Riverside Energy Park

Letter to Ingrebourne Valley Limited
(Bob Dunn Way/University Way)

8.02.30

**Riverside Energy Park - Cory Environmental Holdings Limited (Cory) -
Ingrebourne Valley Limited (Bob Dunn Way/University Way)**

Title: Ingrebourne Valley Limited
Sheet 1 of 1
Option Agreement Plan
Land Comparison

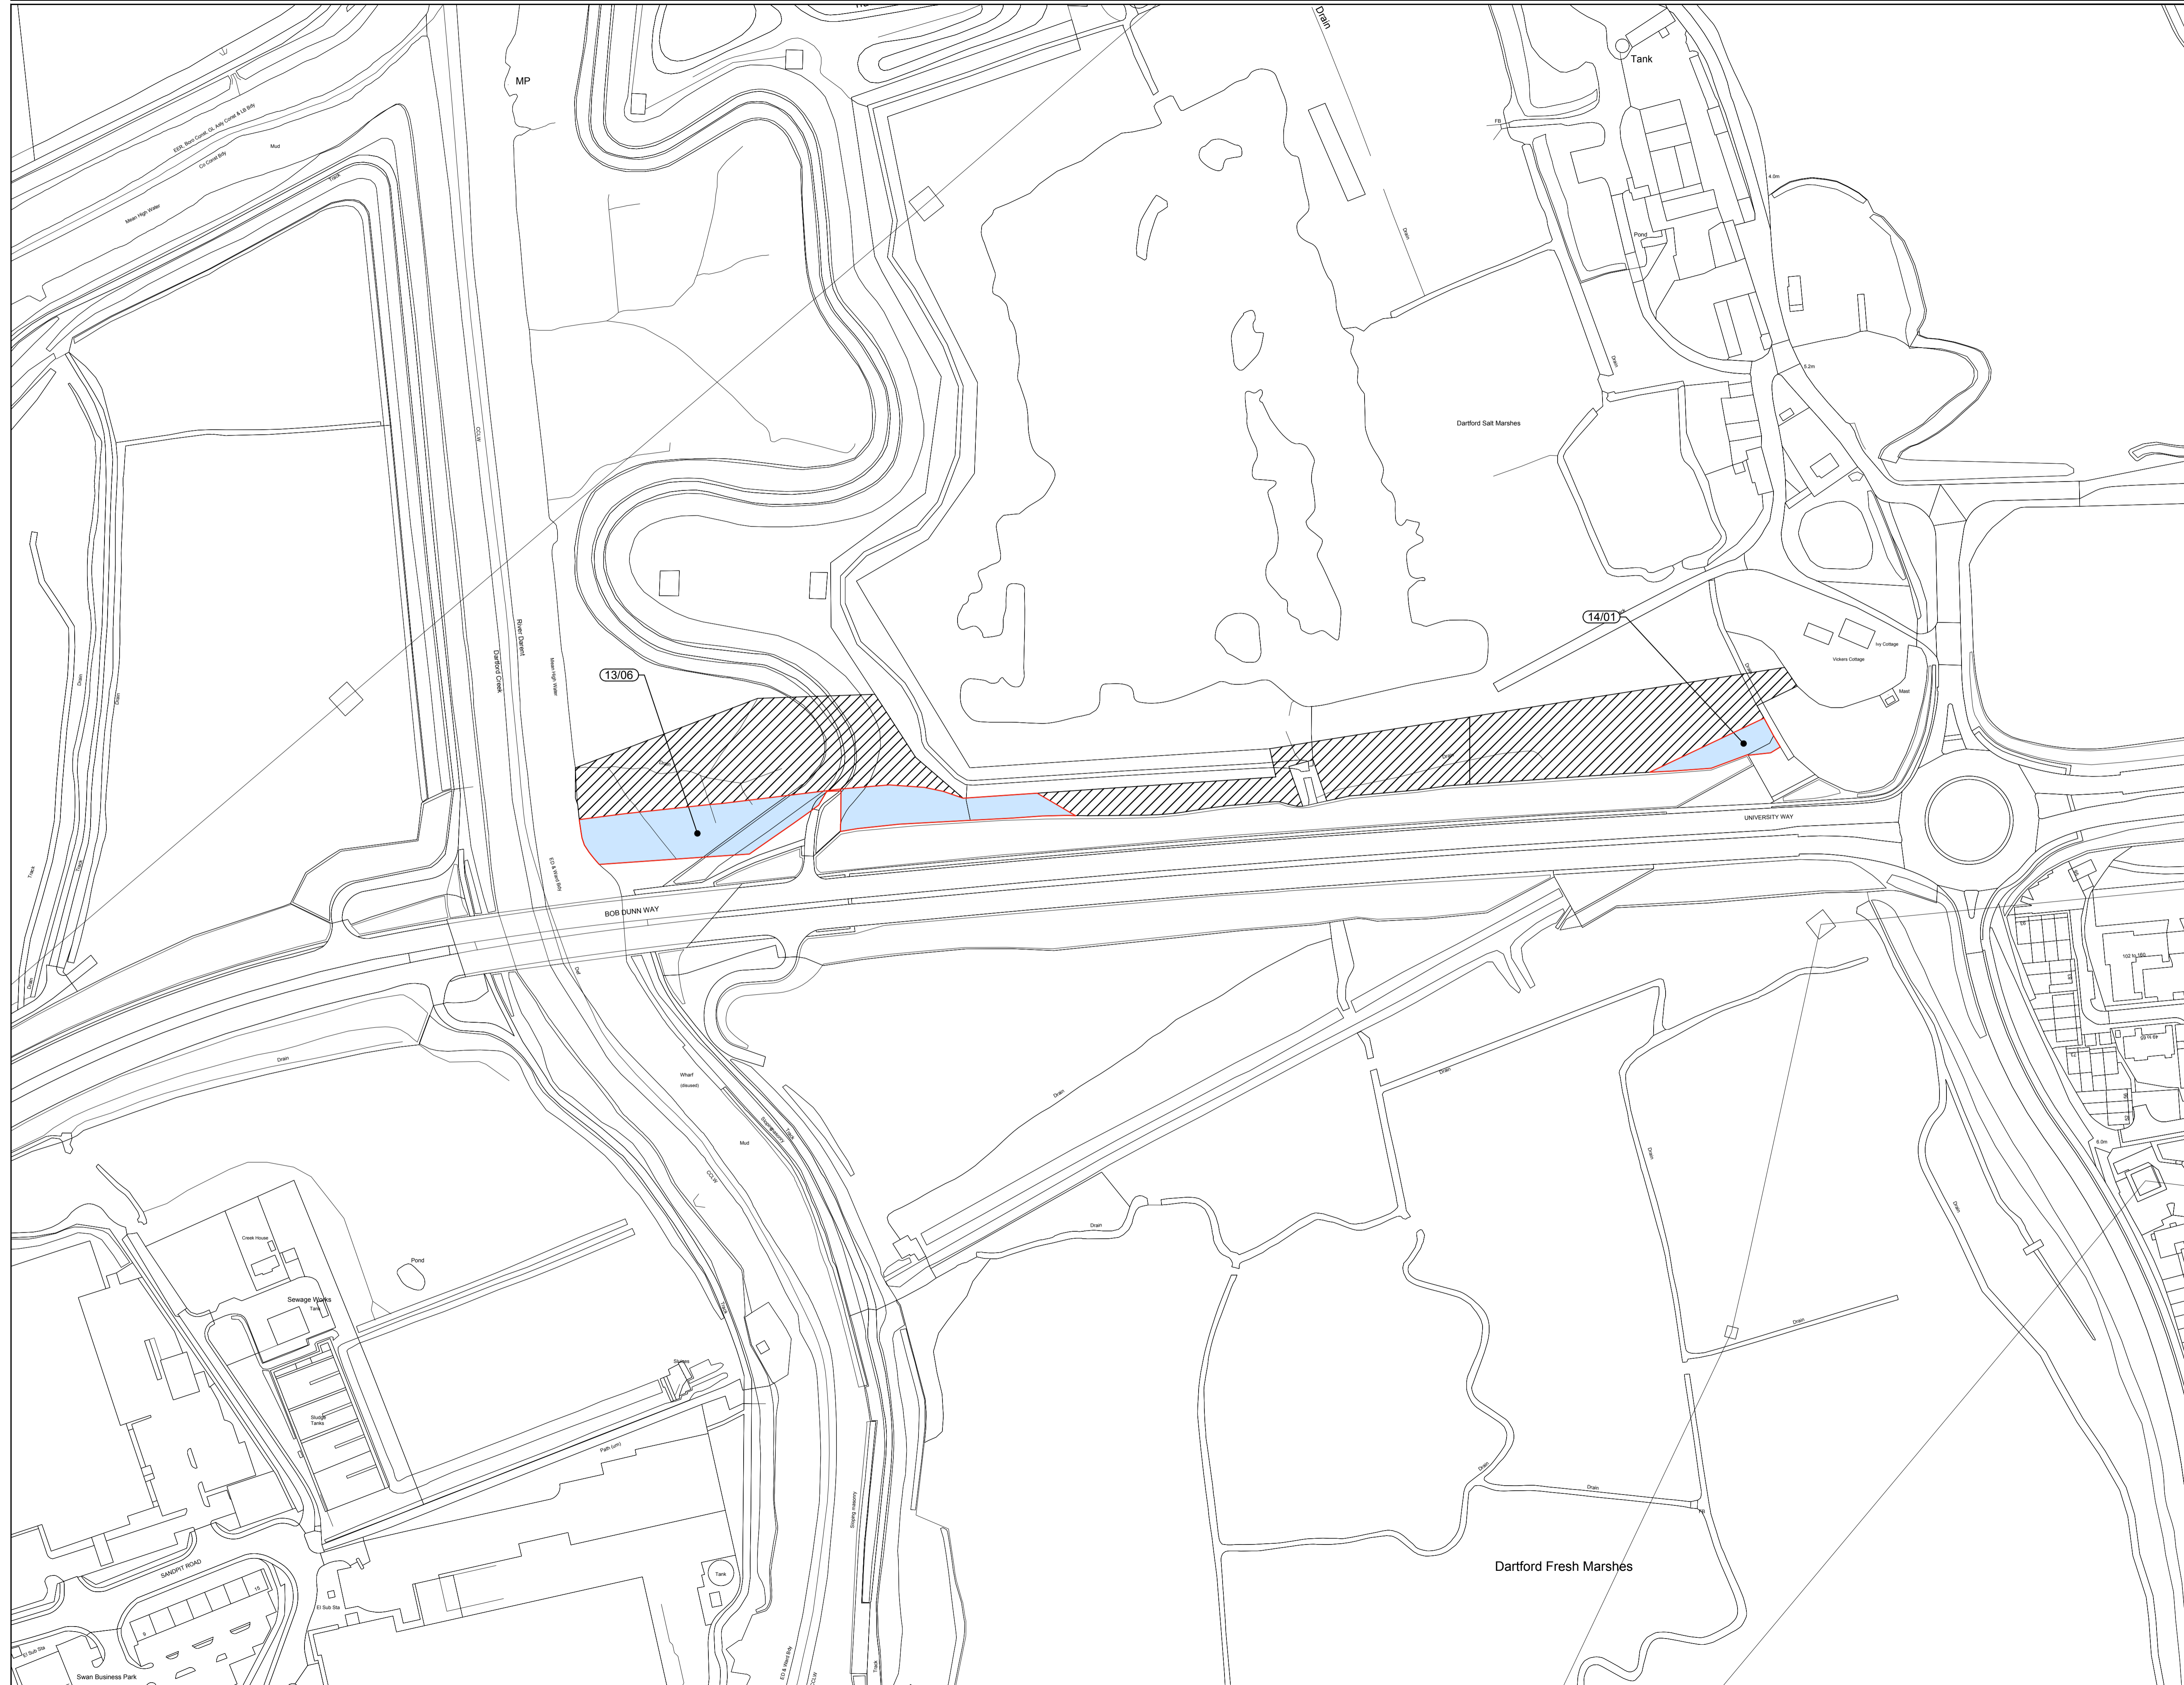
The purpose of this letter is to set out the change which has been submitted to the Examining Authority. This change is a reduction in the area sought through the Application in respect of your "land" north of the existing highway (Bob Dunn Way/University Way) and the extent to which the works there may affect terrestrial biodiversity. The reduction in area is shown on Sheets 13 and 14 of plans which was submitted to the Examining Authority at the Deadline 2 (20th May 2019) whilst the commitments in respect of species and receptor areas are set out in an updated Outline Biodiversity and Landscape Mitigation Strategy to be submitted imminently at the Examining Authority's Deadline 3 (18th June 2019).

I have attached a revised draft option agreement plan which shows a comparison between the land at submission previously and the now revised boundary limits. The land removed is shown hatched black (34,245 sq m) The Order land retained (21,806 sq m) is shown blue edged red.

The extent of works as a result is significantly reduced. Open trenching and the working area would lie outside the position of current reptile fencing. On this basis the revised proposals would have a minimal effect on the reptile receptor site. In the unlikely event that the reptile fencing removed at the time of construction, measures will be employed to avoid impacts to reptiles which may have moved from the receptor site into the construction area.

Adjacent to the River Darent the extent of area included is significantly reduced and will no longer affect the water vole receptor site. This is on the basis that Cory have taken into consideration the water vole receptor site and it will not be subject to above ground works (i.e. only a trenchless solution would occur at this location) and a five metre buffer will be maintained to fencing within that area.
